**Economic and Social Council**

Economic Commission for Europe**Inland Transport Committee****World Forum for Harmonization of Vehicle Regulations****Working Party on Lighting and Light-Signalling****Ninety-second session**

Device UN Regulations:**UN Regulation No. 148 (Light-Signalling Devices)****Proposal for a Supplement to the 01 series of amendments to
UN Regulation No. 148 and to the 06, 07, 08 and 09 series of
amendments to UN Regulation No. 48****Submitted by the expert from the International Automotive Lighting
and Light-Signalling Expert Group ***

6.27.5. Projection area

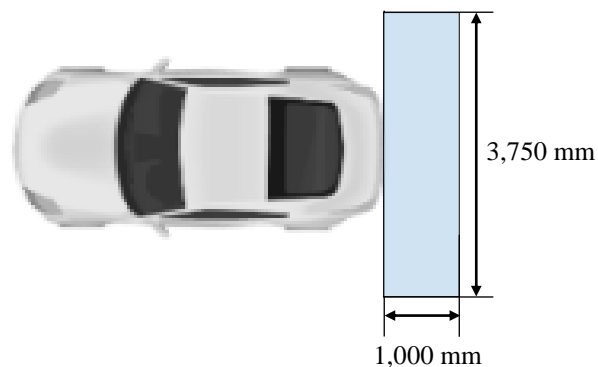
- 6.27.5.1. The lateral distance from the outer edge of the projection with respect to the longitudinal plane of the vehicle shall not be more than 1,875 mm. The longitudinal distance from the farthest edge of the projection shall not be more than 3,000 mm from the backward extreme outer edge of the vehicle (see figure below).**

- 6.27.5.2. The patterns of the reversing projections shall start with their closest edge within a rectangle, symmetrical to the median longitudinal plane and adjacent to the extreme outer edge of the vehicle, having a length of 1,000 mm and a width of 3,750 mm (see figure below).**

6.28.5. Projection area

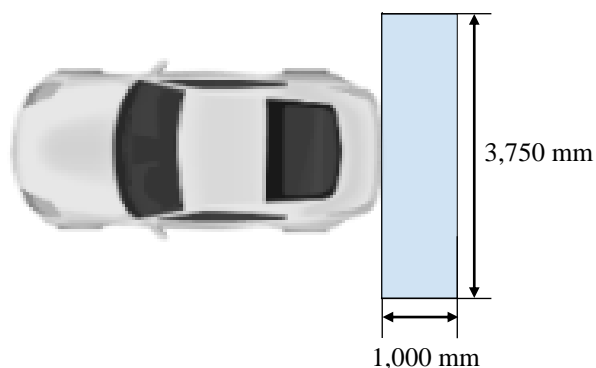
- 6.28.5.1. The lateral distance from the outer edge of the projection with respect to the longitudinal plane of the vehicle shall not be more than 1,875 mm. The longitudinal distance from the farthest edge of the projection shall not be more than 3,000 mm from the backward extreme outer edge of the vehicle (see figure below).**

- 6.28.5.2. The patterns of the reversing projections shall start with their closest edge within a rectangle, symmetrical to the median longitudinal plane and adjacent to the extreme outer edge of the vehicle a width of 1,000 mm and a length of 3,750 mm (see figure below).**
